Oak Bluffs Town Hall Flagpole Modification

Land Use Planning Committee

OB Town Hall Landscape and Lighting Plans

Applicant: Town of Oak Bluffs (Ned Collier, ICON Architecture)
Location: 56 School Street (1.7 acres)
Checklist: 1.3D (Previous DRI)

ELECTRICAL SITE
UTILITY PLAN

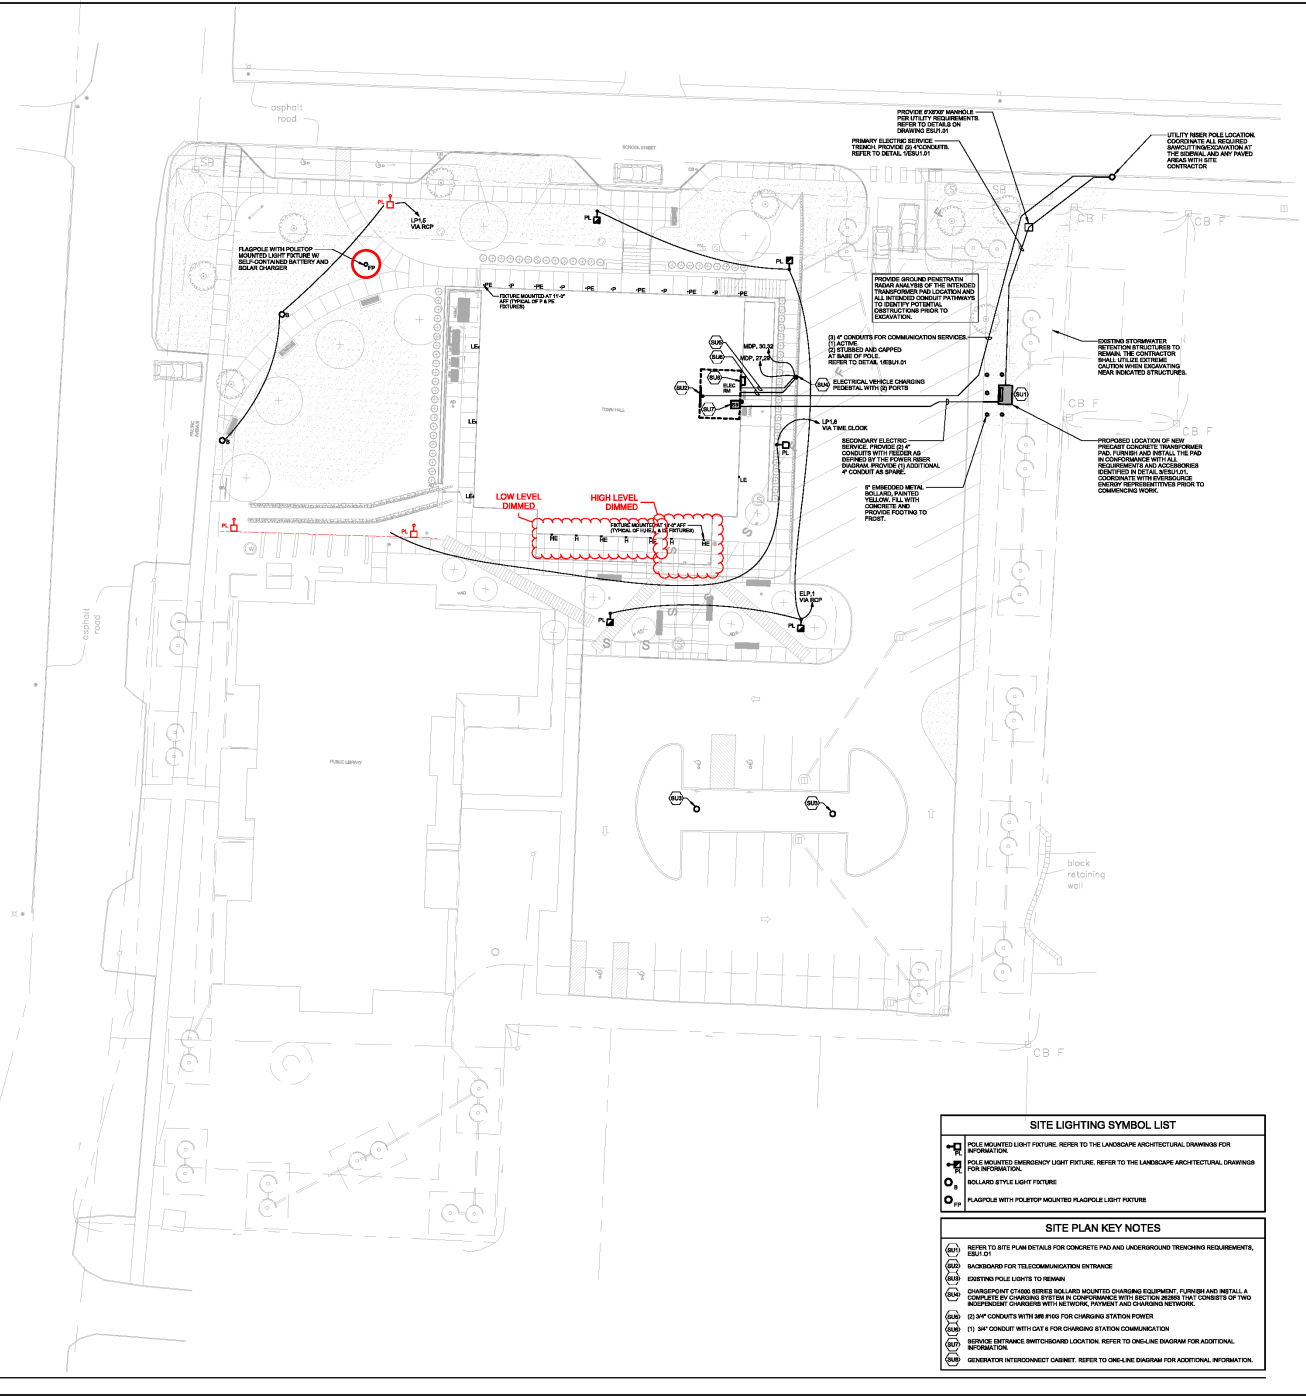
1. Site lighting poles should not exceed 14' in height, with 12' preferred.
2. The two existing parking lot poles should be noted on the plans.
3. One lighting pole should be relocated to the top of the library stairs on Pacific Ave.

4. The poles at the curved walk should be replaced with bollards.
5. The flagpole should be moved north (to the other side of the curved walk) so as to minimize impact on green space. (Approved lighting plan showed correct location.)

6. Lighting at the south portico should focus on the entrance, with reduced lighting for the other fixtures.
7. All exterior lights should be no more than 3,000 degrees Kelvin.

8. The plan should show the location of electric vehicle charging stations.
9. A plan without foot candle readings should be provided.
10. The flagpole light should be included in the lighting calculation.

11. Flagpole light will not be included in the project.
12. The lighting pole for the 2 stairs leading down from Pacific Ave. will be located at the midway point of the stairway.
